**UNITED STATES  
NUCLEAR REGULATORY COMMISSION**  
WASHINGTON, D.C. 20555-0001

December 28, 2016

**SUBJECT: DIABLO CANYON POWER PLANT, UNIT NOS. 1 AND 2 – SAFETY  
EVALUATION REGARDING IMPLEMENTATION OF MITIGATING  
STRATEGIES AND RELIABLE SPENT FUEL POOL INSTRUMENTATION  
RELATED TO ORDERS EA-12-049 AND EA-12-051 (CAC NOS. MF0958,  
MF0959, MF0963, AND MF0964)**

**Figure 1 - Diablo Canyon SFP Levels of Monitoring (Units 1 and 2)**

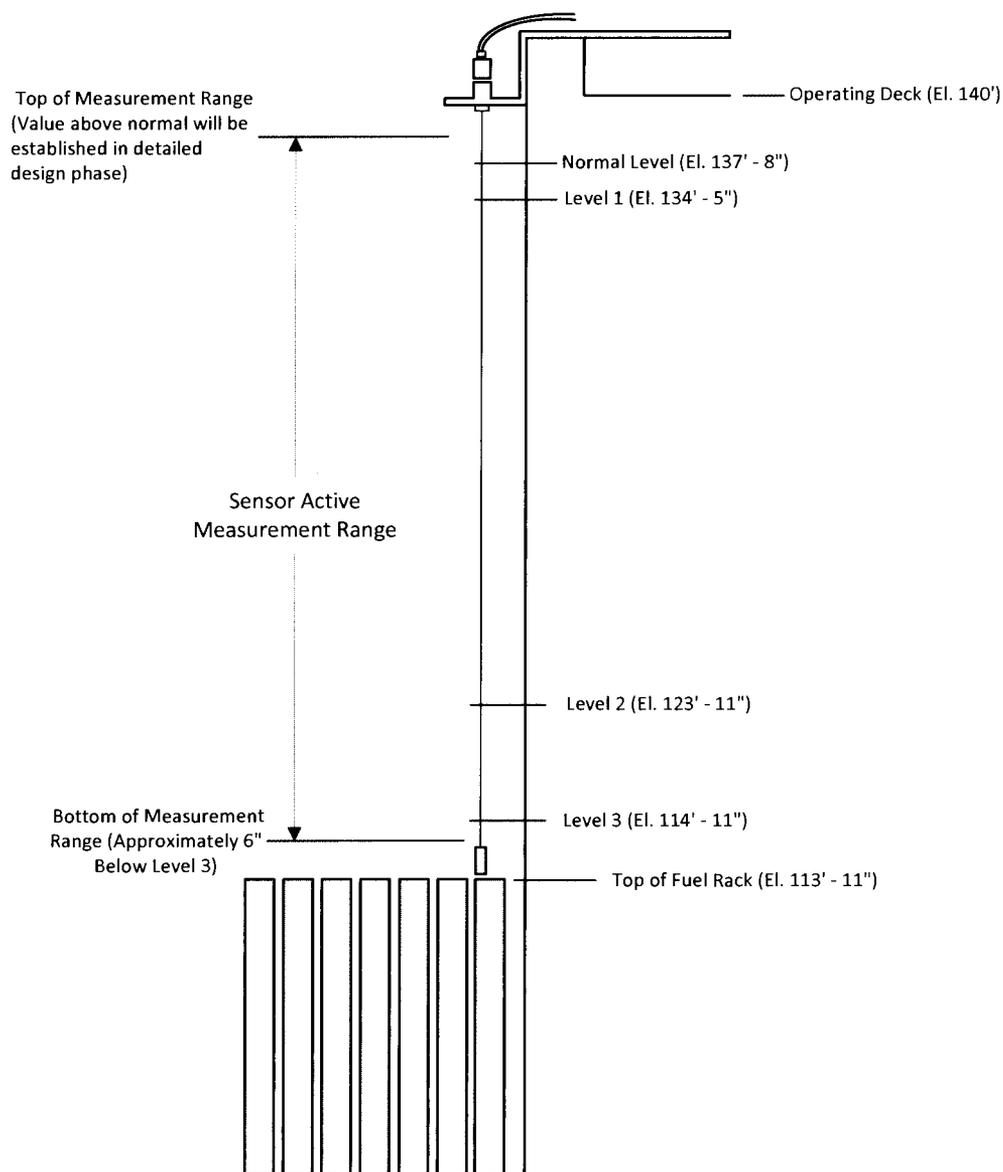
In its letter dated July 18, 2013 (ADAMS Accession No. ML13200A123), the licensee revised the Level 1 from 137 ft. - 8 in. to 134 ft. - 5 in. plant elevation based on the level at which suction loss occurs due to uncovering of the coolant inlet pipe at 134 ft. - 5 in. In the same letter, the licensee provided a sketch depicting the final SFP levels of monitoring and the measurement ranges for the primary and backup instrument channels as shown in Figure 1, "Diablo Canyon SFP Levels of Monitoring (Units 1 and 2)", in this evaluation.

For the revised Level 1, in its letter dated January 5, 2016 (ADAMS Accession No. ML16005A637), the licensee further provided the basis for the change. This basis stated that PG&E Calculation M-648, "Spent Fuel Pool Cooling Pump Hydraulic Performance Analysis," Revisions 1 and 2, performed an evaluation to determine the SFP cooling system pump's required net positive suction head (NPSH) to operate without cavitation at saturated conditions. Drawings 439503 (Unit 1) and 443467 (Unit 2) show the centerline of the 10-inch SFP cooling system inlet pipe is located at elevation 134 ft. Thus the top of the pipe is located at elevation 134 ft. - 5 in., which is Level 1. Calculation M-648, Revision 2, determined the NPSH available (NPSHa) for the SFP Cooling System Pump 1-2 is 21.9 ft. The NPSHa is based on a static head of 35.1 ft. as the difference of the minimum SFP level (Elevation 137 ft. - 4 in.) and the SFP pump inlet elevation (102 ft. - 3 in.). Calculation M-648, Revision 2, concludes that the NPSHa of 21.9 ft. is well above the NPSH required of 14 ft. This is a margin of 7.9 ft. Using Level 1 (Elevation 134 ft. - 5 in.) as the elevation where the SFP cooling system inlet pipe will uncover instead of the minimum SFP level (Elevation 137 ft. - 4 in.), the static head is reduced by 2 ft. - 11 in., which reduces the NPSHa margin from 7.9 ft. to approximately 5 ft. Therefore, sufficient NPSHa is available with a SFP water height at the Level 1 elevation of 134 ft. - 5 in.

In its letter dated July 18, 2013 (ADAMS Accession No. ML13200A123), the licensee provided a sketch depicting the measurement ranges for the primary and backup instrument channels as shown in Figure 1 of this evaluation. The NRC staff noted that the instrument measurement ranges will cover Levels 1, 2, and 3, as described in Section 4.1 above.
